**HISTORIC AND DESIGN REVIEW
COMPLIANCE AND TECHNICAL ADVISORY BOARD
February 23, 2024**

HDRC CASE NO: 2024-045
ADDRESS: 504 N HACKBERRY ST
LEGAL DESCRIPTION: NCB 570 BLK 6 LOT N 56.05 FT OF 13-14
ZONING: C-2, H
CITY COUNCIL DIST.: 2
DISTRICT: Dignowity Hill Historic District
APPLICANT: Richard Gonzalez | Chapawu Properties LLC
OWNER: Richard Gonzalez | Chapawu Properties LLC
TYPE OF WORK: Front fence installation; front porch steps, porch decking, and wood window replacement; chimney removal; and fenestration modifications
APPLICATION RECEIVED: January 15, 2024
60-DAY REVIEW: March 5, 2024
CASE MANAGER: Bryan Morales

1. Install a front yard cattle-panel fence with a pedestrian and driveway gate.
2. Replace the front porch steps.
3. Replace the front porch decking.
4. Remove the existing chimney.
5. Replace wholesale the wood windows on the property.
6. Modify the existing fenestration pattern.

1 SITE PLAN
SCALE: $1/4" = 1'-0"$

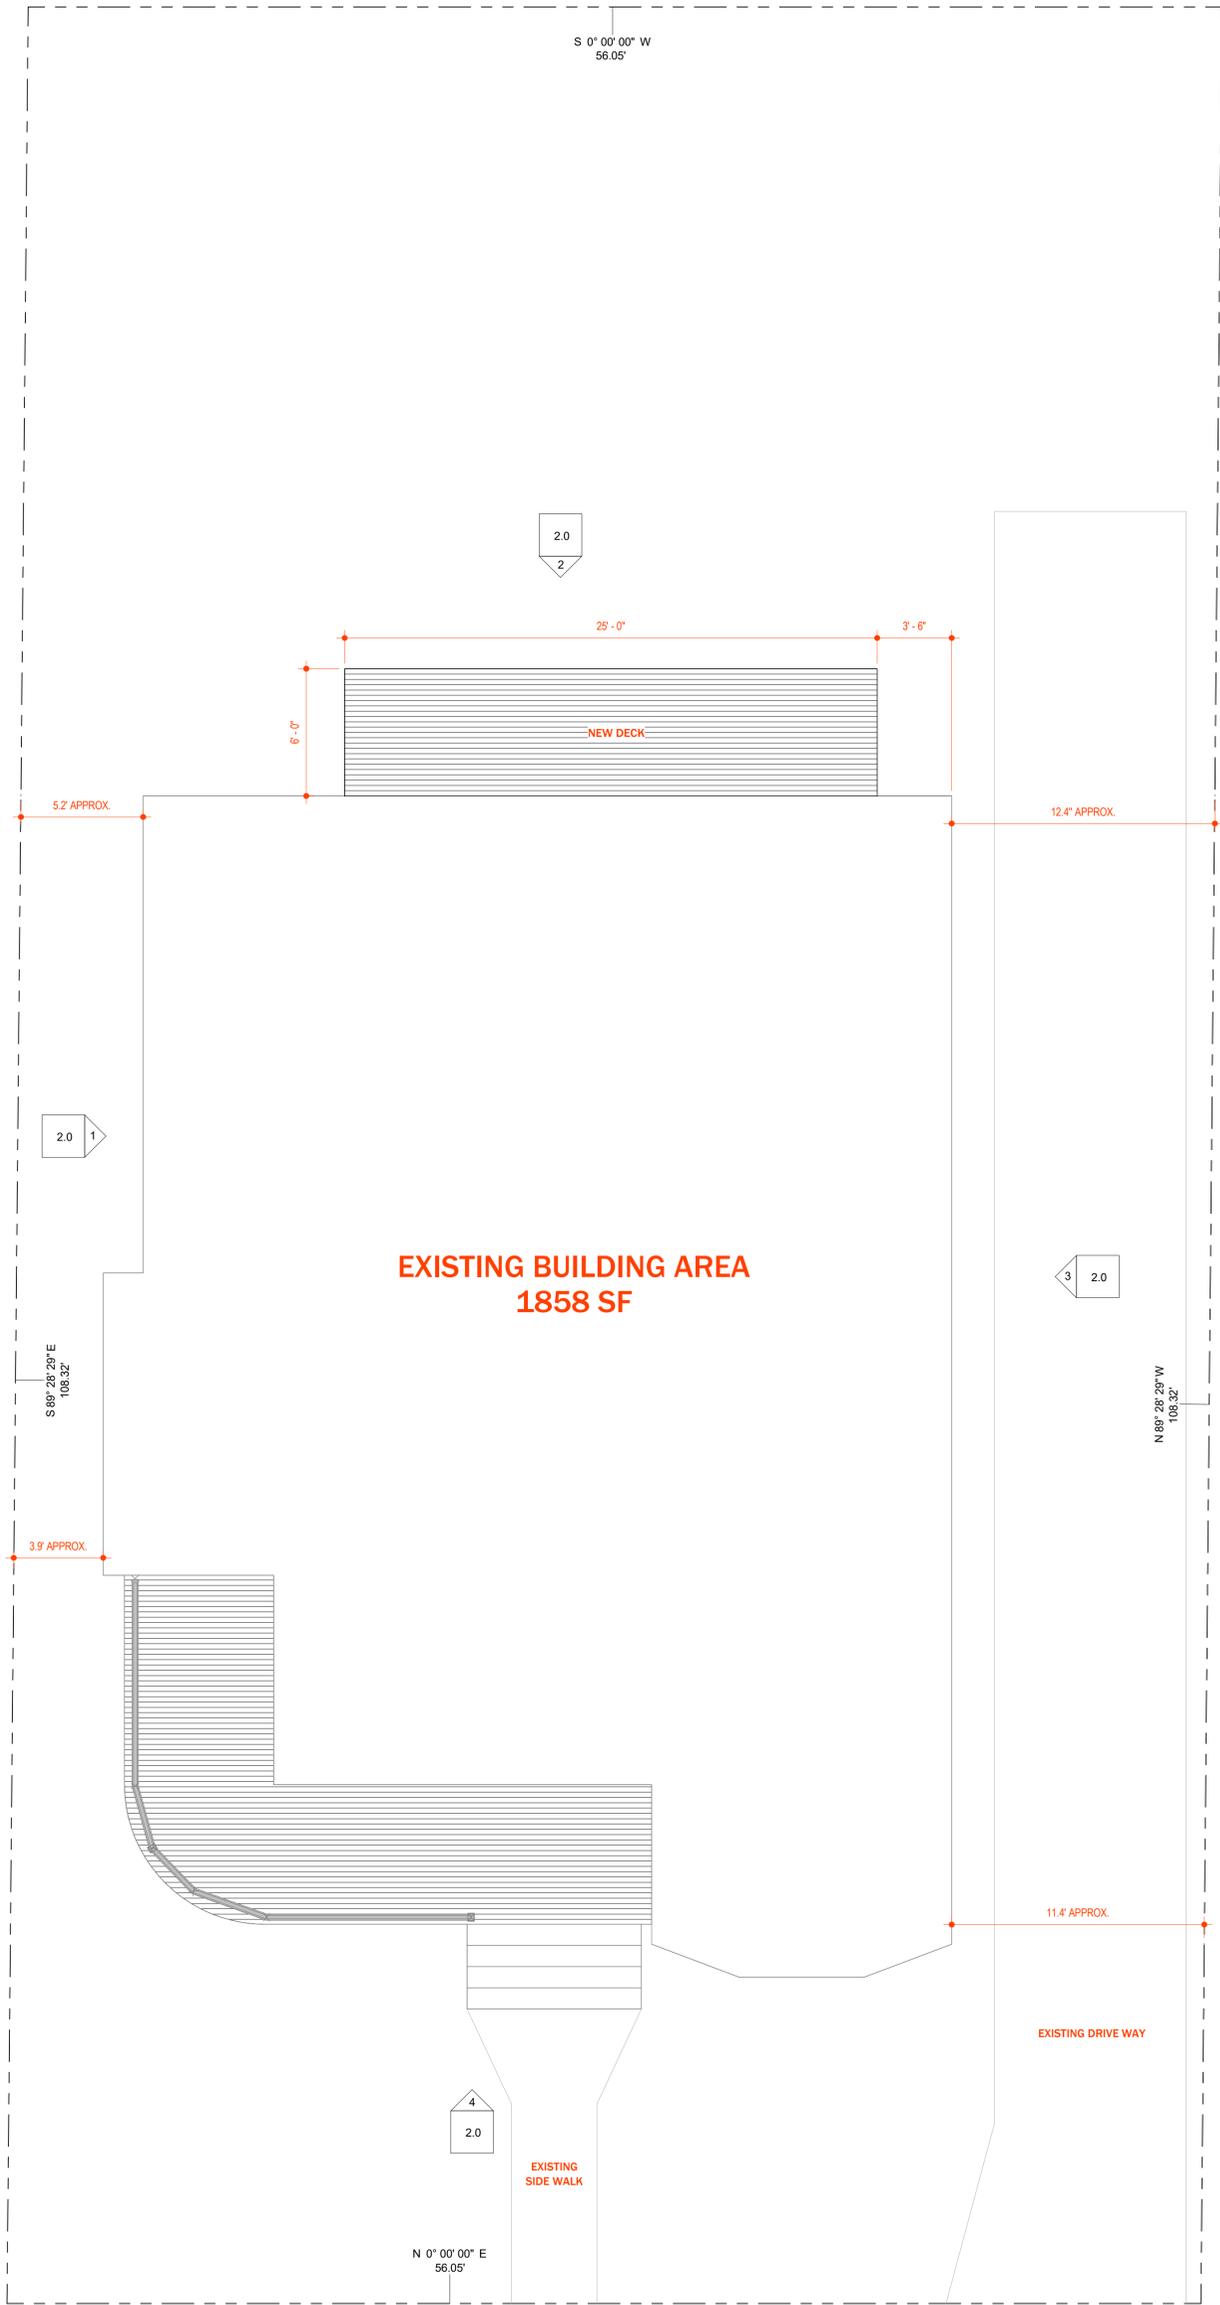
- e. FRONT YARD FENCE & PEDESTRIAN GATE – The applicant is requesting to construct a four feet tall wood post and rail cattle-panel front yard fence with a pedestrian gate in-kind. The Historic Design Guidelines for Site Elements 2.B.i. states new fences and walls should appear similar to those used historically within the district in terms of their scale, transparency, and character, and the design of the fence should respond to the design and materials of the house or main structure. Site Elements 2.B.iii. states to limit the height of new fences and walls within the front yard to a maximum of four feet. Site Elements 2.B.v. states to construct new fences or walls of materials similar to fence materials historically used in the district. Staff finds the installation of the front yard fence and pedestrian gate generally appropriate.

- f. DRIVEWAY GATE – The applicant is requesting to construct a four feet tall wood post and rail cattle-panel driveway gate flush with the right-of-way. Site Elements 2.B.i. states new fences and walls should appear similar to those used historically within the district in terms of their scale, transparency, and character, and the design of the fence should respond to the design and materials of the house or main structure. Site Elements 2.B.iii. states to limit the height of new fences and walls within the front yard to a maximum of four feet. Site Elements 2.B.v. states to construct new fences or walls of materials similar to fence materials historically used in the district. The Fences in Historic Districts Policy Document states vehicle gates should be set behind the front façade plane of the house and not span across the front driveway. Staff finds the proposed location of the driveway gate does not conform to guidelines.

- i. That the fence and gates height does not exceed four feet.
- ii. That the driveway gate be placed behind the front façade of the main structure.
- iii. That the applicant install 1x3" wood tongue and groove porch decking running perpendicular to the front façade with a slight slope toward the front yard.

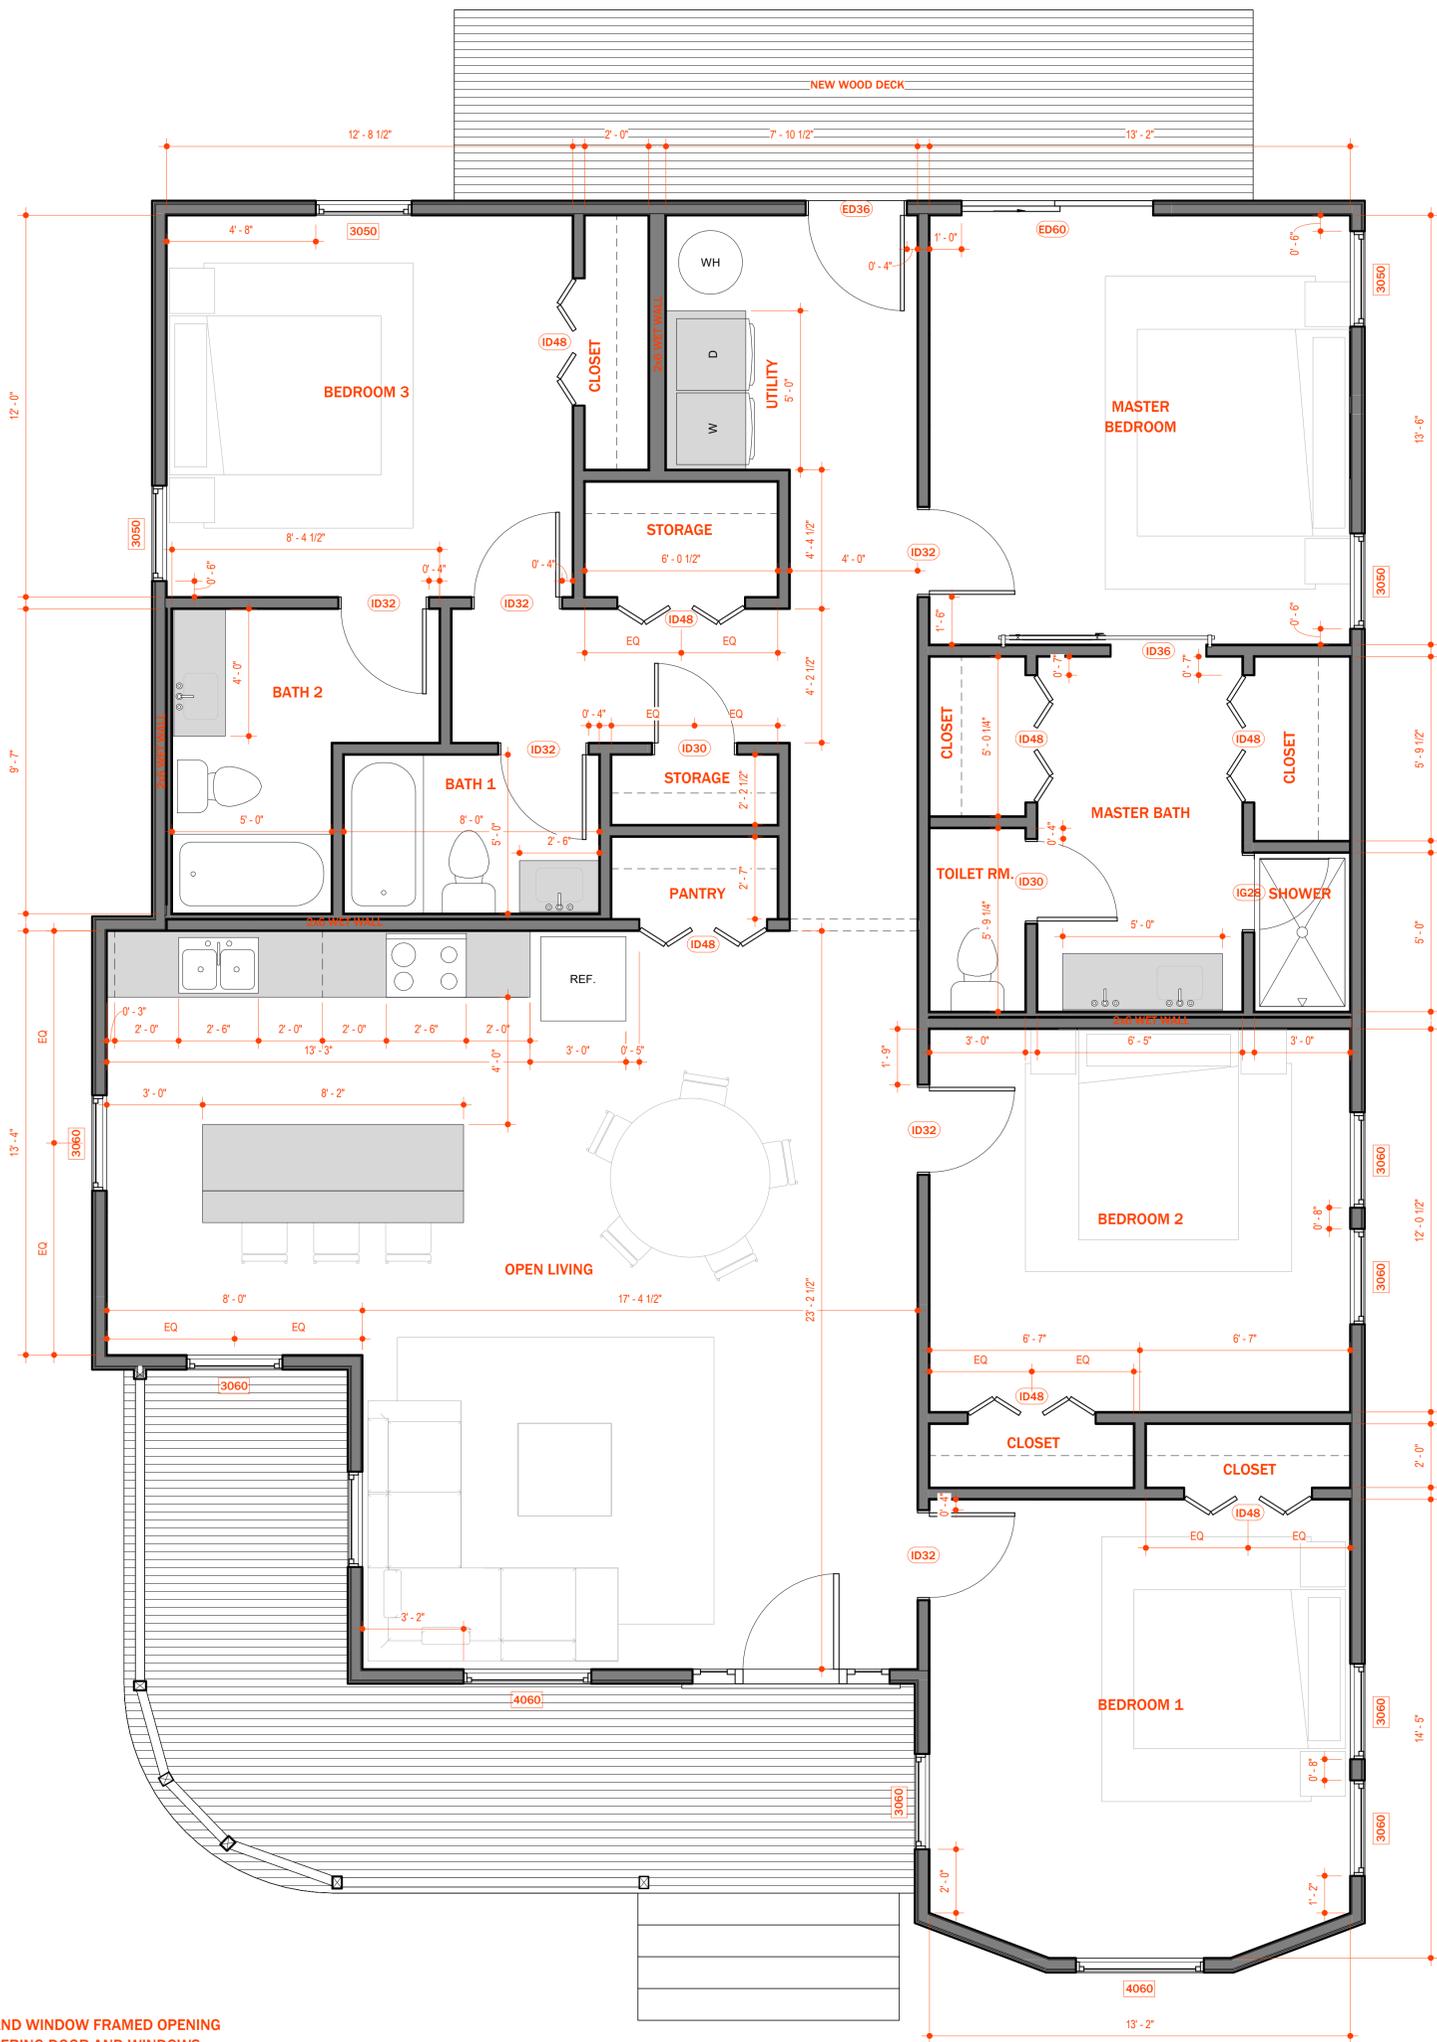
- n. FENESTRATION MODIFICATIONS (WEST) – The applicant is requesting to modify the existing window openings on the west façade. Exterior Maintenance and Alterations 6.A.i. states to preserve existing window openings and to avoid enlarging or diminishing to fit stock sizes. Staff finds the proposed modifications to the window openings on the west façade do not conform to guidelines.

- o. FENESTRATION MODIFICATIONS (SOUTH) – The applicant is requesting approval to infill three windows and modify five window openings on the south façade. Exterior Maintenance and Alterations 6.A.i. states to preserve existing window openings and to avoid enlarging or diminishing to fit stock sizes. Exterior Maintenance and Alterations 6.A.iii. states to preserve historic windows. Exterior Maintenance and Alterations 6.A.iv. states to install new windows to match the historic or existing windows in terms of size, type, configuration, material, form, appearance, and detail when original windows are deteriorated beyond repair. Staff finds the proposed fenestration modifications to the south façade does not conform to guidelines.

- p. FENESTRATION MODIFICATIONS (NORTH) – The applicant is requesting approval to infill two windows, add one window opening, and modify two window openings on the north façade. Exterior Maintenance and Alterations 6.A.i. states to preserve existing window openings and to avoid enlarging or diminishing to fit stock sizes. Exterior Maintenance and Alterations 6.A.iii. states to preserve historic windows. Exterior Maintenance and Alterations 6.A.iv.

states to install new windows to match the historic or existing windows in terms of size, type, configuration, material, form, appearance, and detail when original windows are deteriorated beyond repair. Staff finds the proposed fenestration modifications to the north façade does not conform to guidelines.

Staff does not recommend approval of items 4 through 6 based on findings a and i through p. Staff recommends the applicant restore the previous conditions which includes the chimney reconstruction and wood windows, with trim, in the same historic fenestration pattern (sizes and locations of openings).
